**SUBJECT: Comments on Lemberger Landfill Source Control Evaluation, Lemberger Landfill, Whitelaw, Manitowoc County, Wisconsin, September 2015”, Transmitted to USEPA 11 September 2015**

**Comments on Report from TRC for LSRG Entitled “Lemberger Landfill Source Control Evaluation, Lemberger Landfill, Whitelaw, Manitowoc County, Wisconsin, September 2015”, Transmitted to USEPA 11 September 2015**

Figure: LH-06 and LH-07 heads vs time, plotted as heads above the base of the well (not as elevations). Only data since the cessation of leachate extraction are plotted.

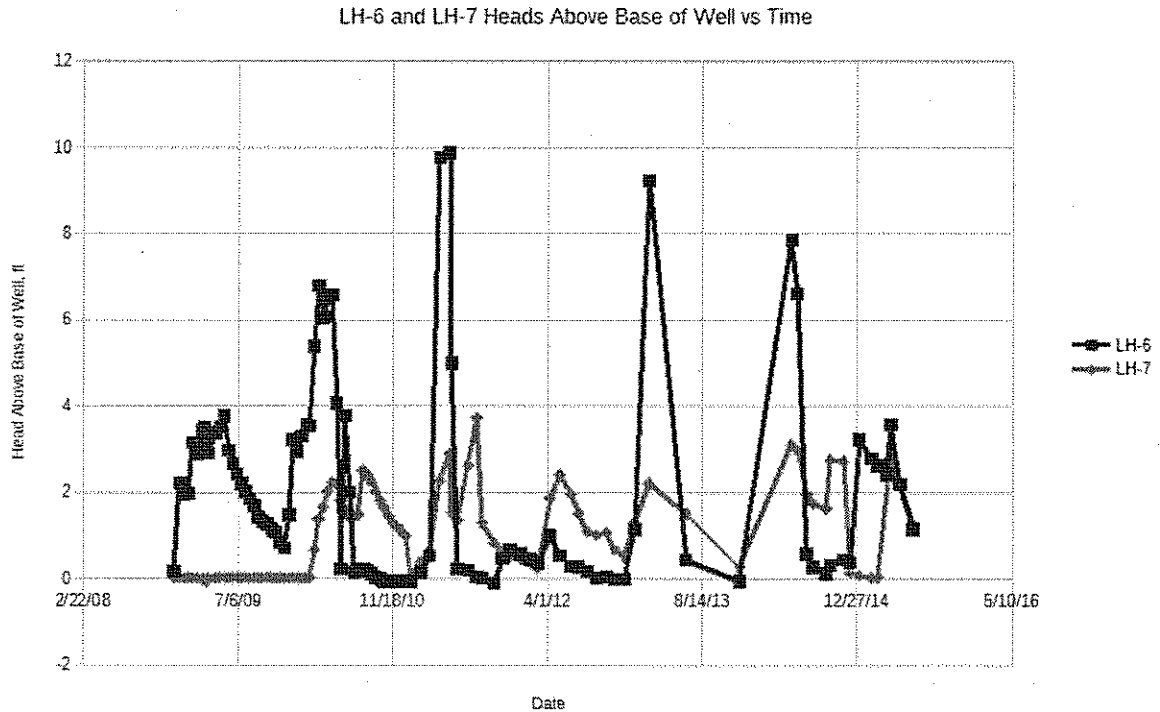
1. The following figure shows the water levels above the bottom of the well versus time since the end of leachate well pumping (12/10/2008). The plot shows that LH-06 responds to impulse recharge to a greater degree than LH-07. It also shows that after an impulse causes a rise in water level, there is a slower response

(decay) at LH-07 than at LH-06. Note that in the initial months after leachate pumping ended, the water level above base of well was essentially zero at LH-07 much longer than at LH-06—we hypothesize that this is simply water level at LW-01 did not rise above the base of LH-07 for those months. (See PDF pages 32-34.) Note also that there are some cases where the magnitude of the rise at LH-07 is (uncharacteristically) greater than at LH-06, such as in April 2012; we hypothesize that the peak rise at LH-06 was not observed given the frequency in the water level monitoring program. This makes sense because LH-06 responds quite rapidly to impulses of infiltration.
